UNITED STATES PATENT AND TRADEMARK OFFICE

APPLICATION NO.	FILING DATE	FIRST NAMED INVENTOR	ATTORNEY DOCKET NO.	CONFIRMATION NO.
10/555,090	11/02/2005	Yutaka Kitamura	Q90831	9358
23373 7590 06/07/2007 SUGHRUE MION, PLLC 2100 PENNSYLVANIA AVENUE, N.W. SUITE 800 WASHINGTON, DC 20037			EXAMINER DESAI, NAISHADH N	
			ART UNIT	PAPER NUMBER
			2809	
			MAIL DATE	DELIVERY MODE
			06/07/2007	PAPER

<b>Office Action Summary</b>	<b>Application No.</b>		<b>Applicant(s)</b>	
	10/555,090		KITAMURA ET AL.	
	<b>Examiner</b>		<b>Art Unit</b>	
	Naishadh N. Desai		2809

## **DETAILED ACTION**

**FIG. 2**

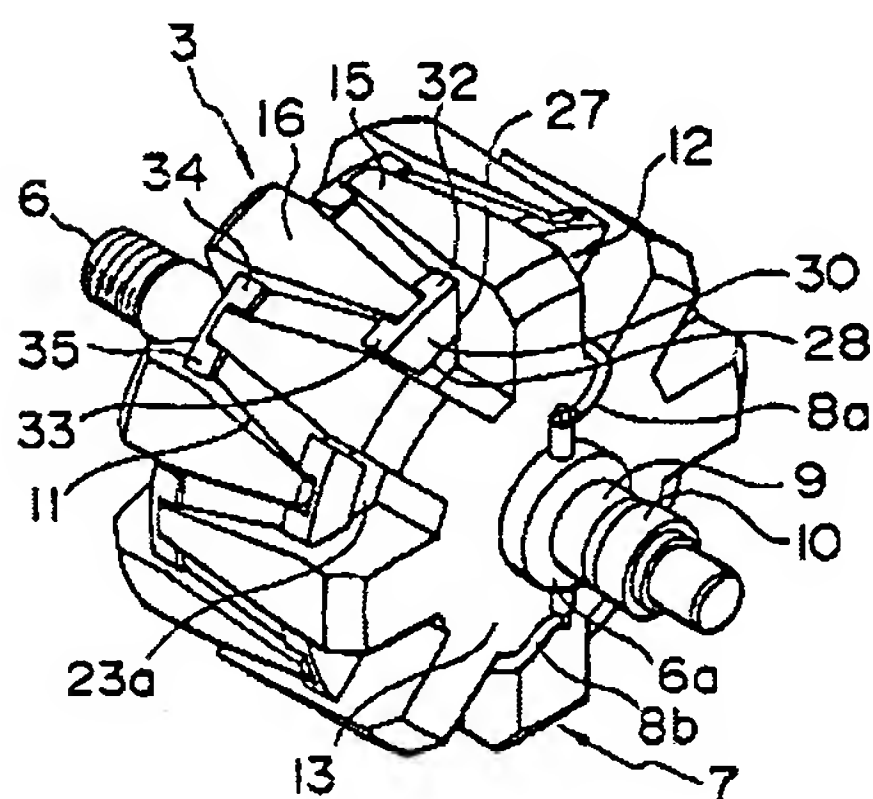
a rotor iron core including a magnetic pole part formed into a claw-pole type in which adjacent magnetic poles are different from each other and a cylindrical part having the field winding(Fig 2 of Kusase et al shows a claw pole type rotor core with adjacent magnetic poles to be different from each other and the winding is contained within the cylindrical part), and

Ihata teaches the vehicular rotating electrical machine as discussed above. Ihata does not teach a claw pole type rotor. Kusase et al teaches a rotor with adjacent claw like magnetic poles. It would have been obvious at the time the invention was made to one having ordinary skills in the art to modify the device of Ihata to include the teachings of Kusase et al to make a rotor with claw like magnetic poles. The motivation to do so is that it would allow achievement of low noise and prevent generation of high frequency impact magnetic noise.
